**AMENDMENTS TO THE DRAWINGS:**

## REMARKS

Fig.1

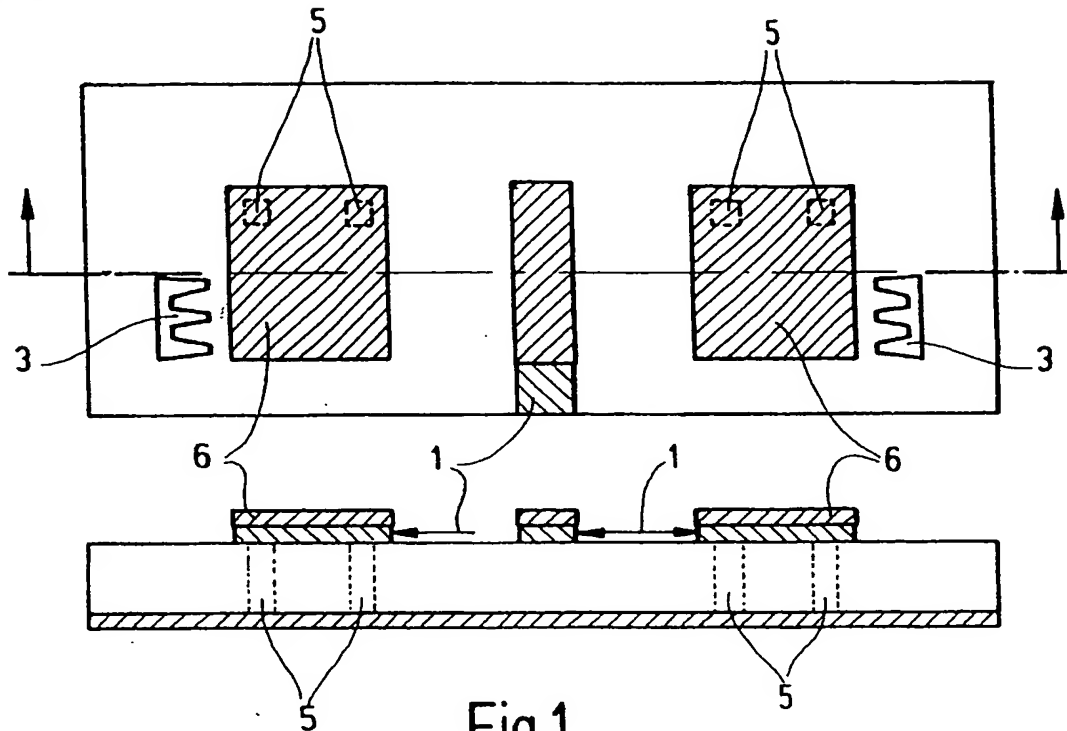
Please label Fig. 1 with the legend "*prior art*" as indicated on the marked-up and replacement sheets set forth in the Appendix following page 7 herein.

The legend "*Prior Art*" was added to Fig. 1, as required.

*Prior Art*
